**BOARD OF COUNTY COMMISSIONERS  
ORANGE COUNTY, FLORIDA**

**ADDENDUM NO. 3 / IFB NO. Y18-729-TA**

**SOUTH WATER RECLAMATION FACILITY INFLUENT PUMP STATION  
IMPROVEMENTS**

The following graphic information corresponds to Drawing sheet M02.

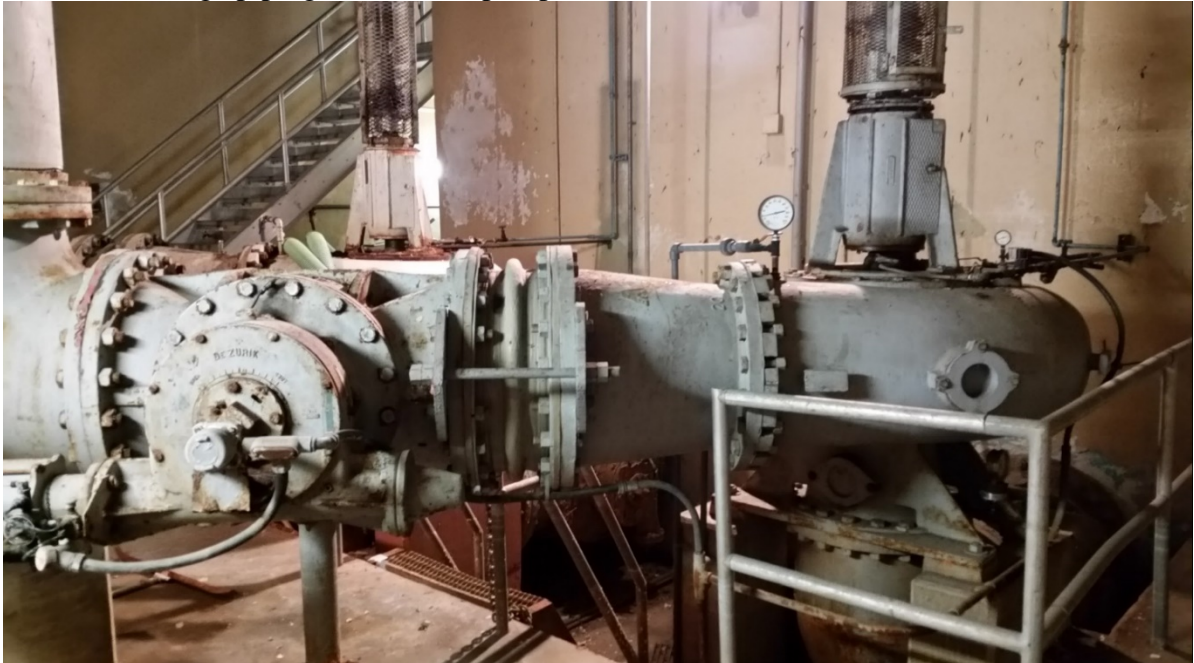
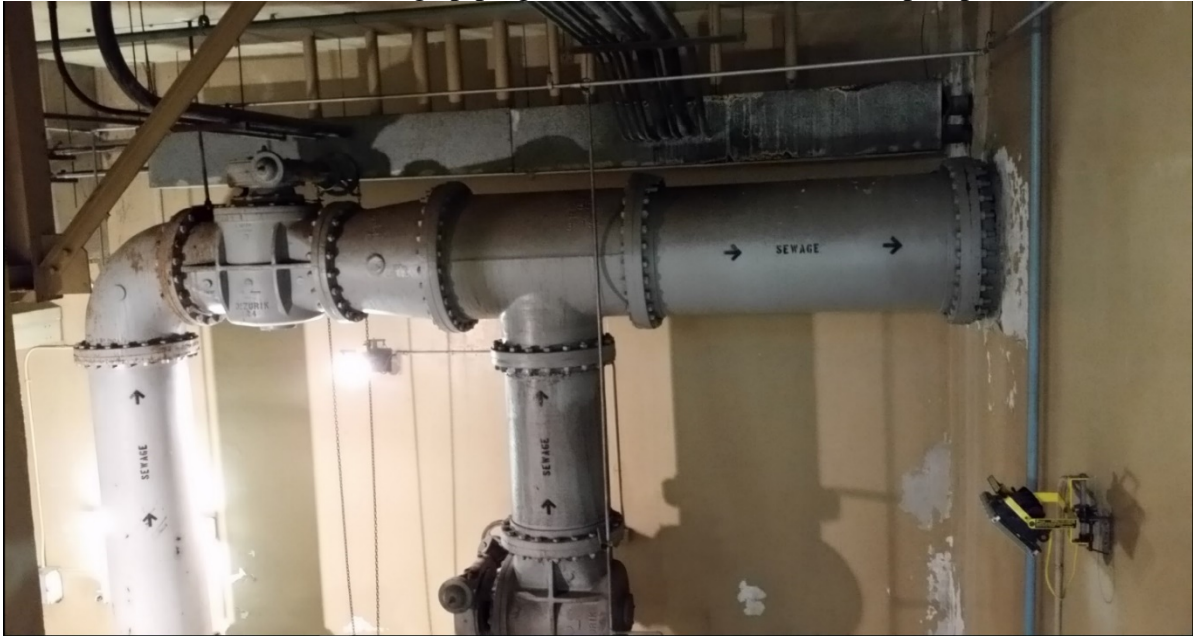
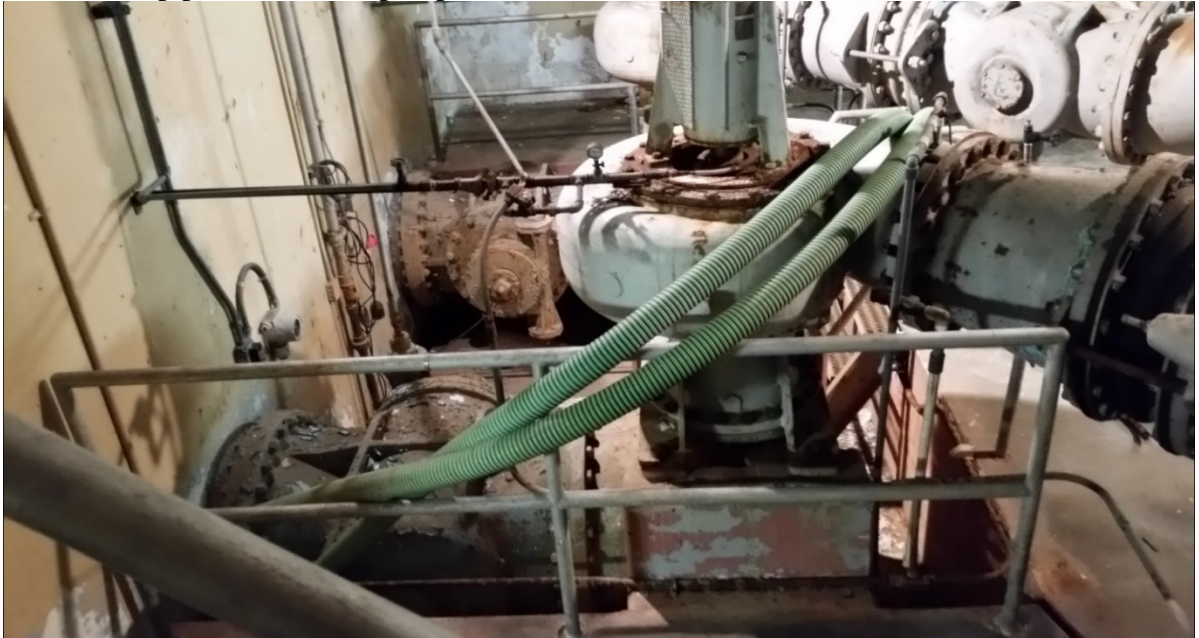
**a. Note 1 on drawing M02 states to “See information for bidders in appendix for additional information.” Appendices A thru D provided with the bid documents do not address the demolition of the OLD IPS. Please clarify.**

A. See Appendix E attached and added to the specifications.

SCALE: NOTED  
 DRAWING NO.:  
**S02**  
 SHEET: 41 OF 123

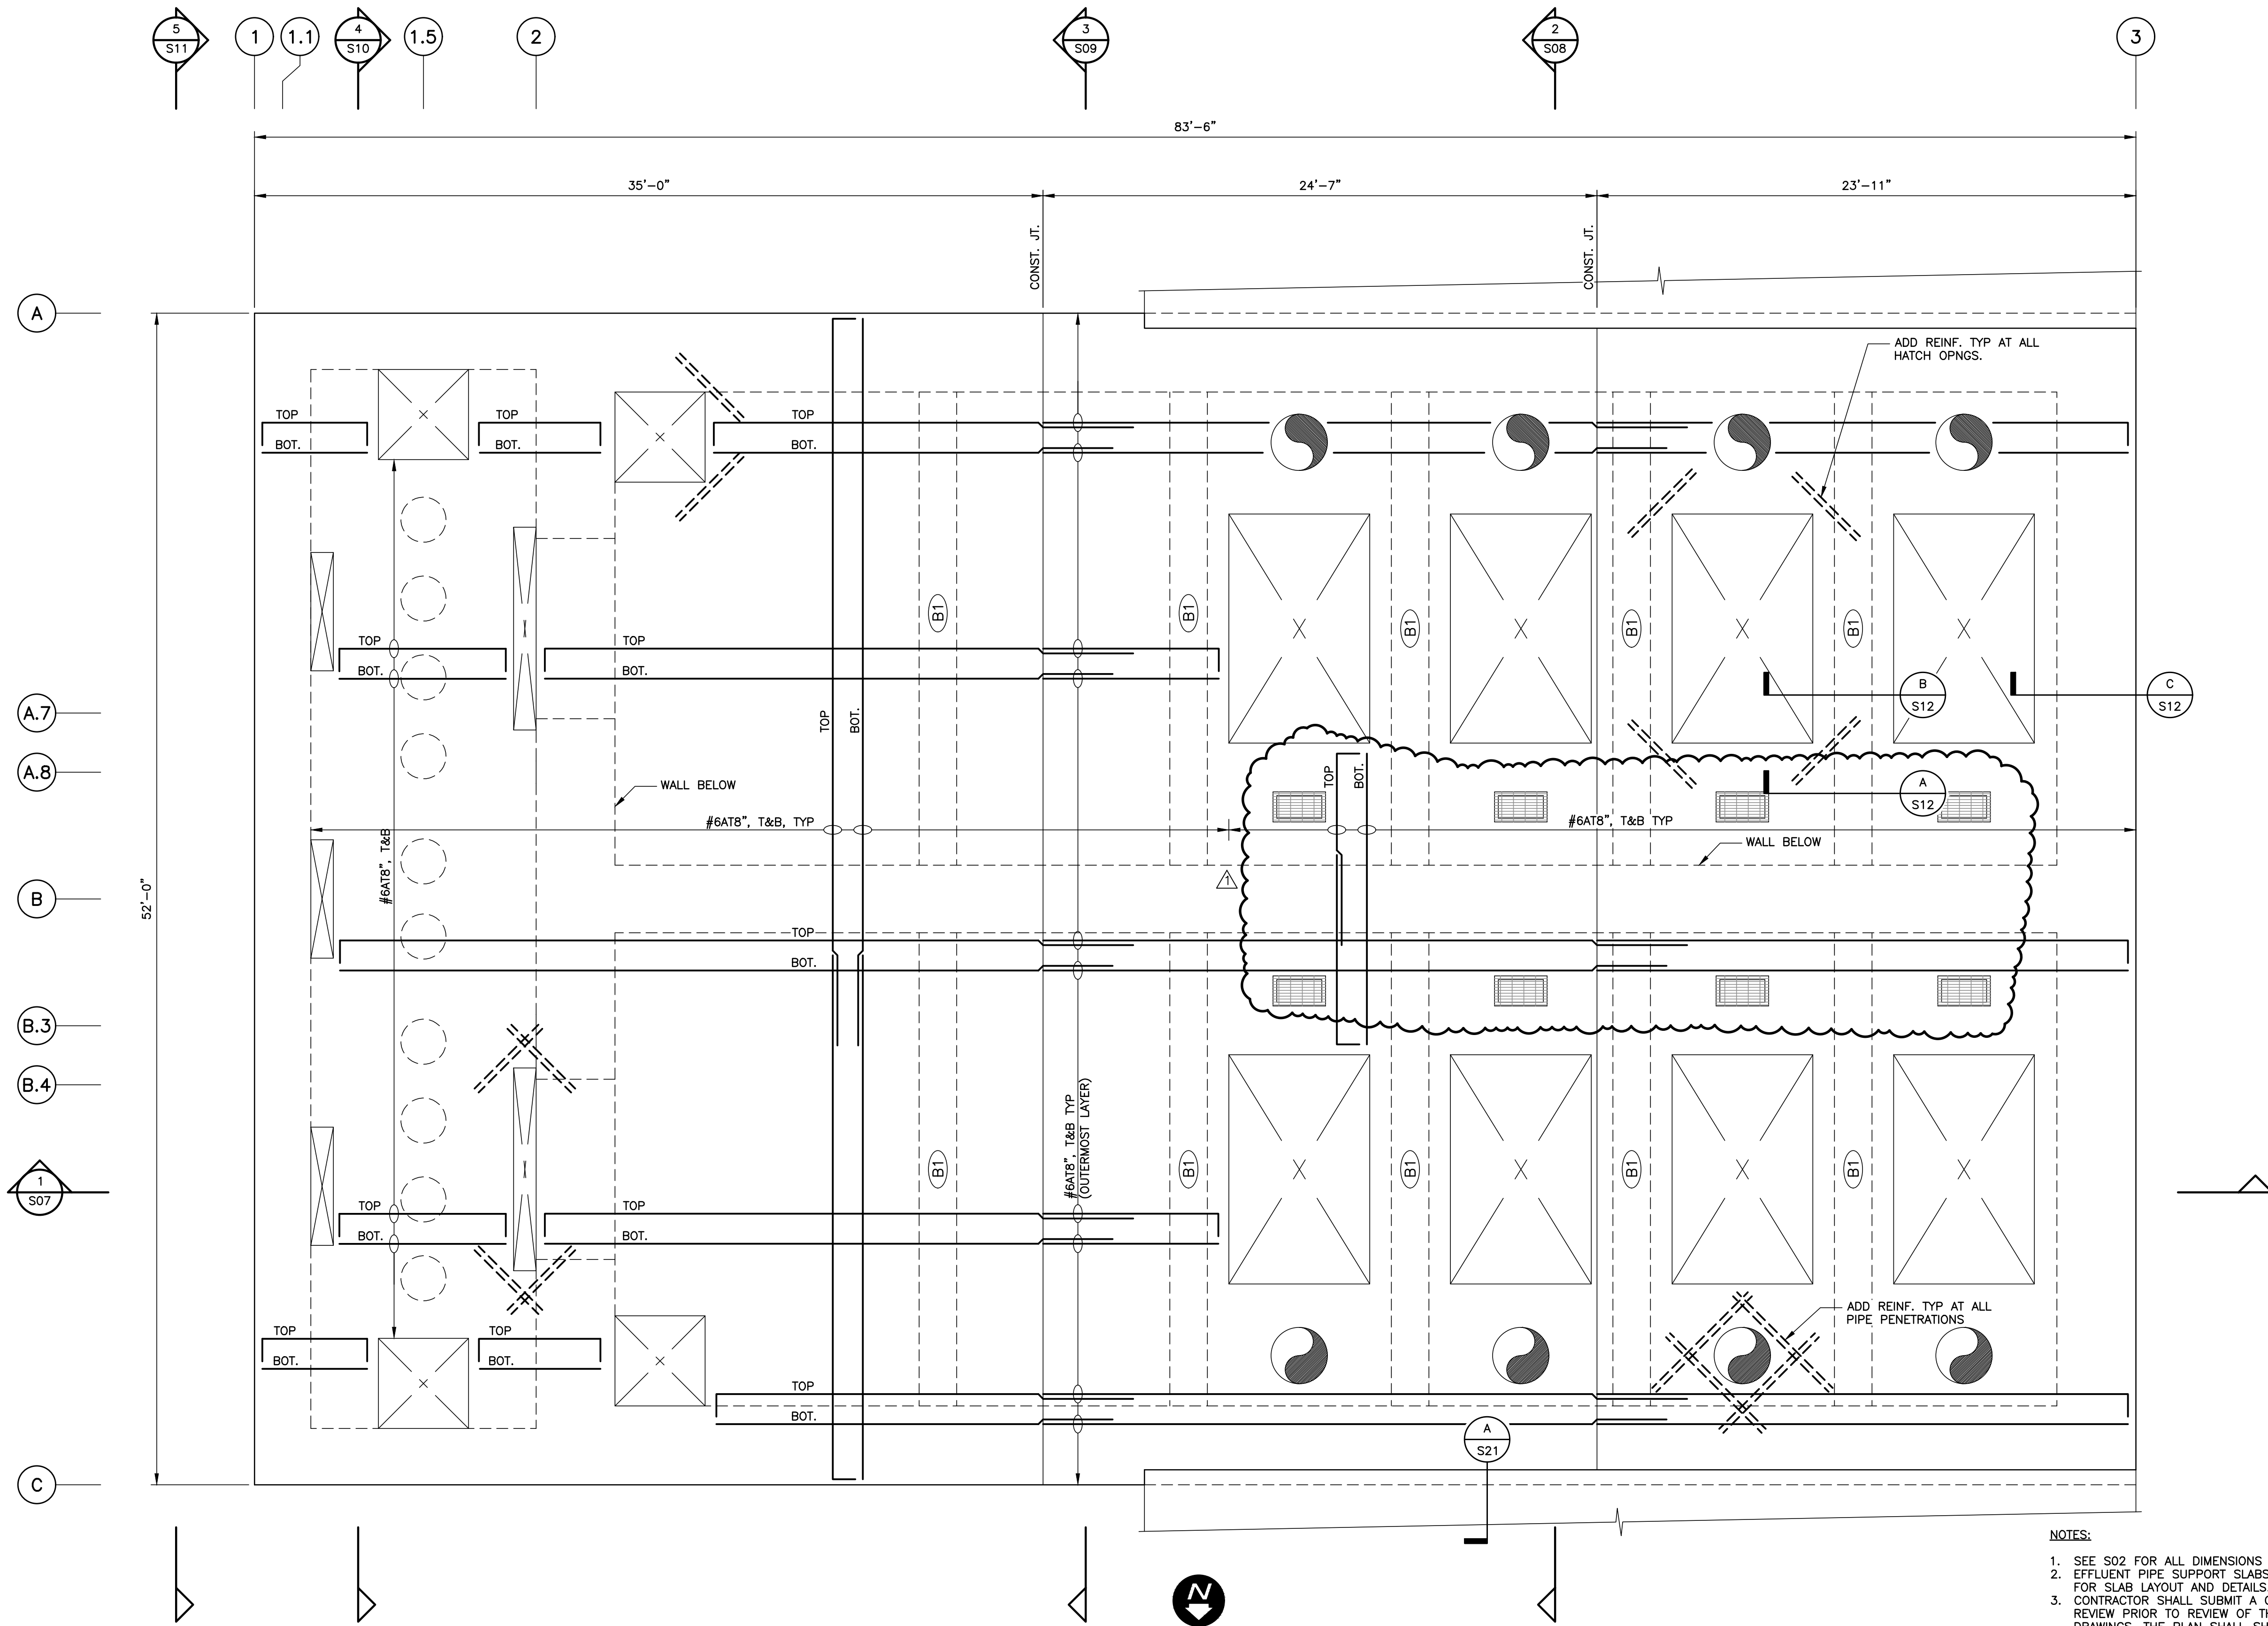
1. **Drawing S02 to be deleted in its entirety and replaced with the attached Revised S02 drawing.**
2. **Drawing S03 be deleted in its entirety and replaced with the attached Revised S03 drawing.**
3. **Drawing S17 to be deleted in its entirety and replaced with the attached Revised drawings S17 and S17A.**

SCALE: NOTED
DRAWING NO.: S17
SHEET: 56 OF 123

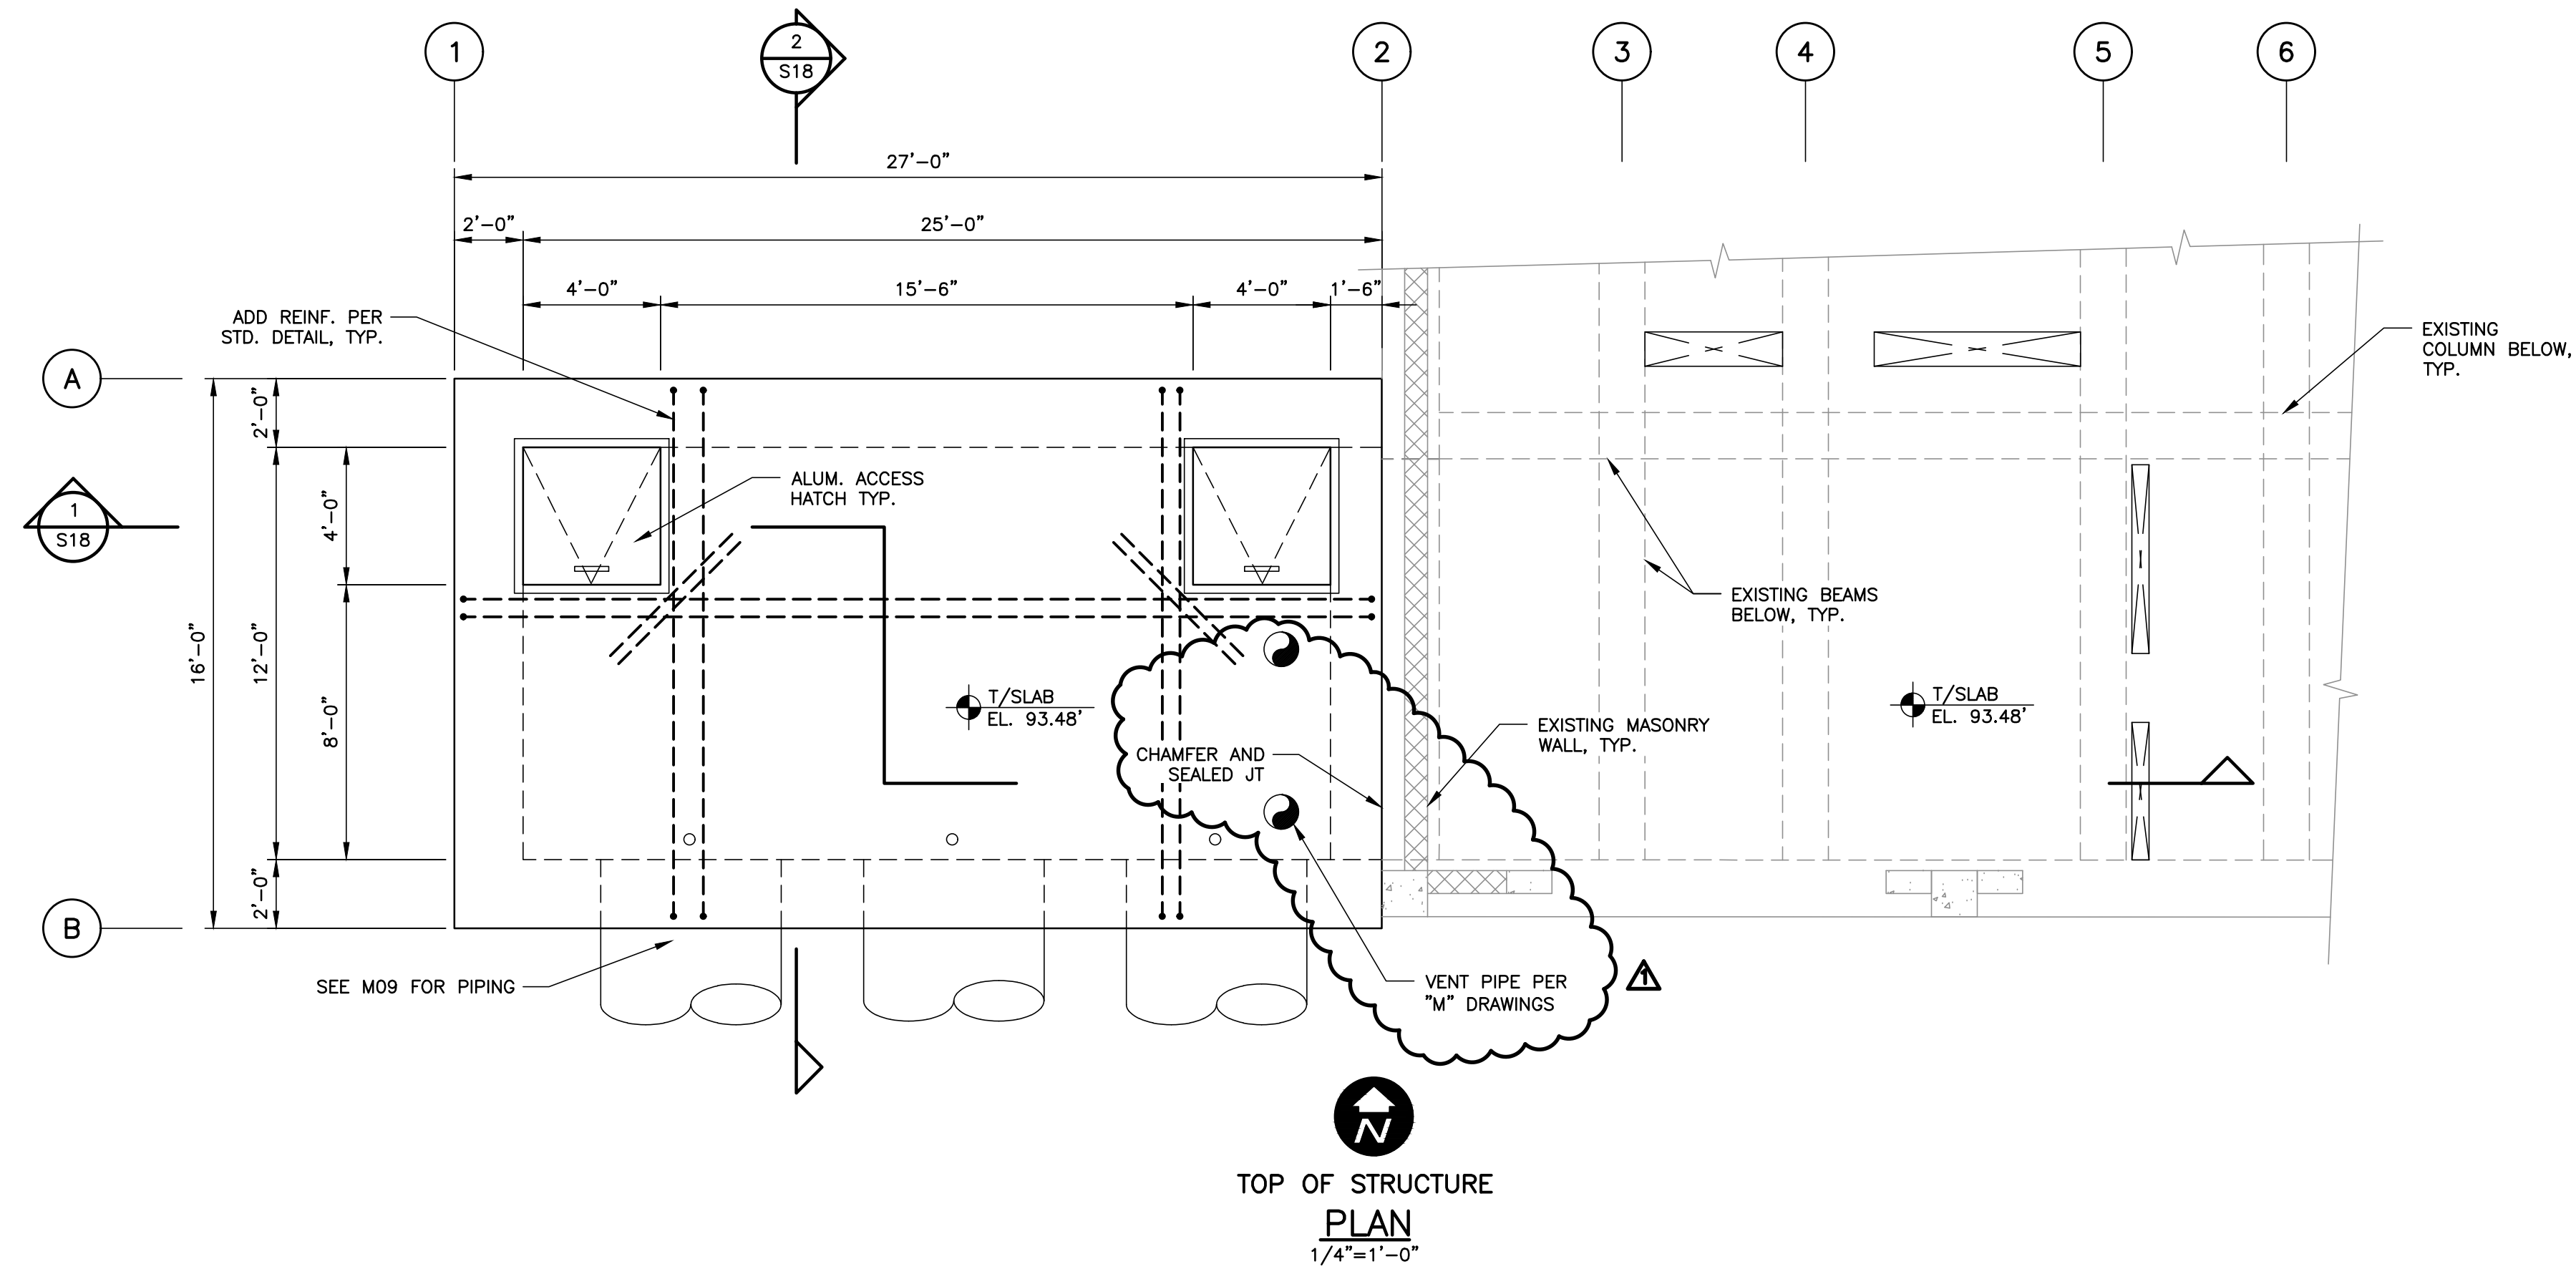
**a. Is this wall doveled into the existing perimeter wall and if so at what spacing and embedment.**

A. No, the only mechanical attachment to the existing structure is at the base slab and at wall lines A and B as shown on the Base Slab Plan on S17.
